**PR/1626/21**

## **Record of Executive Business and Chief Executive's Order**

**Reg. Reference:** SD21B/0542      **Application Date:** 26-Oct-2021  
**Submission Type:** New Application      **Registration Date:** 26-Oct-2021

**Proposed Development:** Removal of existing single storey extension and sheds to side and rear of house; construction of two storey extension to side of house and single storey extension to front of house; new vehicle entrance to front; new boundary treatments.

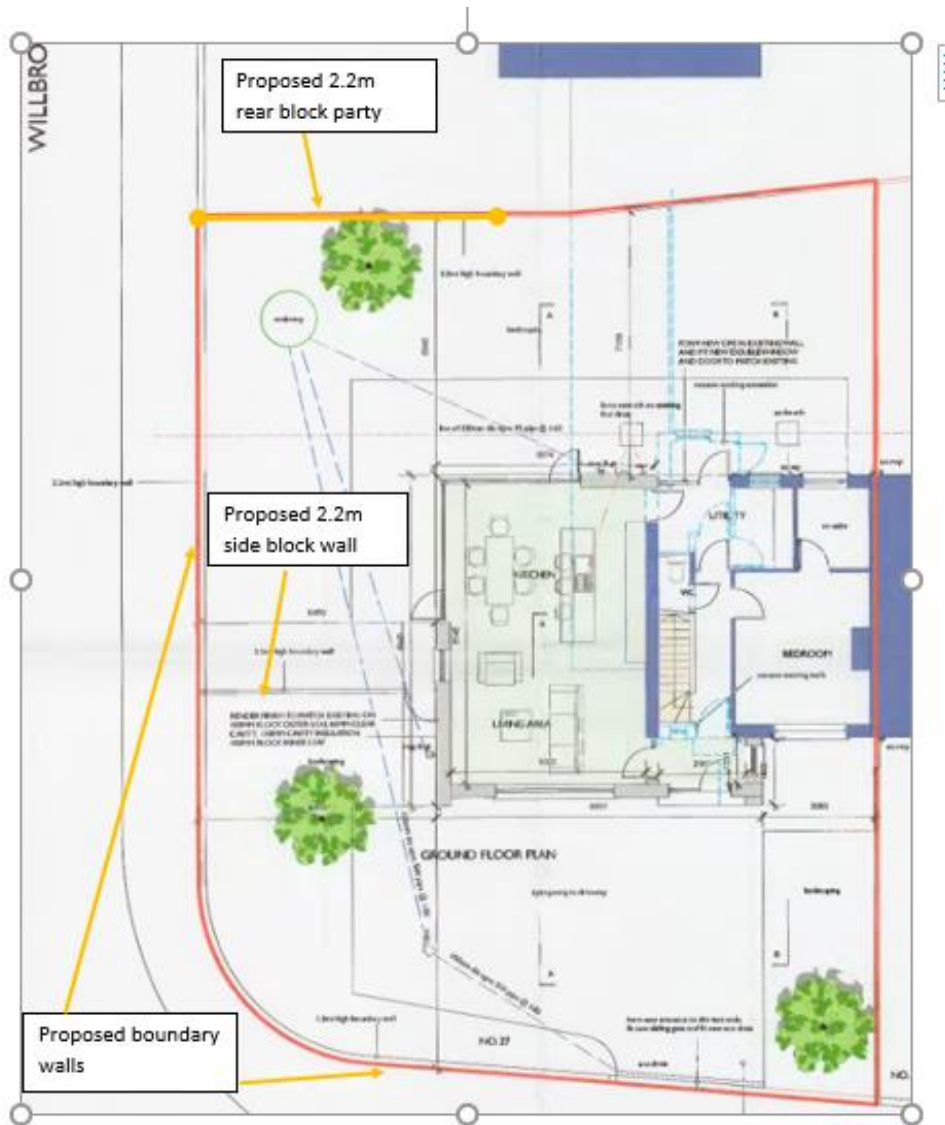
*1.The proposed vehicular access point limited to a width of 3.5 meters.*

*2.The proposed 2.2m high rear block party wall limited to a max. height of 0.9m where it projects in front of property at 2 Willbrook Park in the interest of traffic safety and for visibility for vehicles egressing 2 Willbrook Park.*

*3.The proposed 2.2m high side block wall dividing the front and rear gardens limited to a max. height of 0.9m in the interest of traffic safety and for visibility for vehicles egressing 2 Willbrook Park.*

*4.All other proposed boundary treatment limited to a maximum height of 0.9m, and any boundary pillars limited to a maximum height of 1.2m, in the interest of traffic safety and to improve forward visibility for vehicles.*
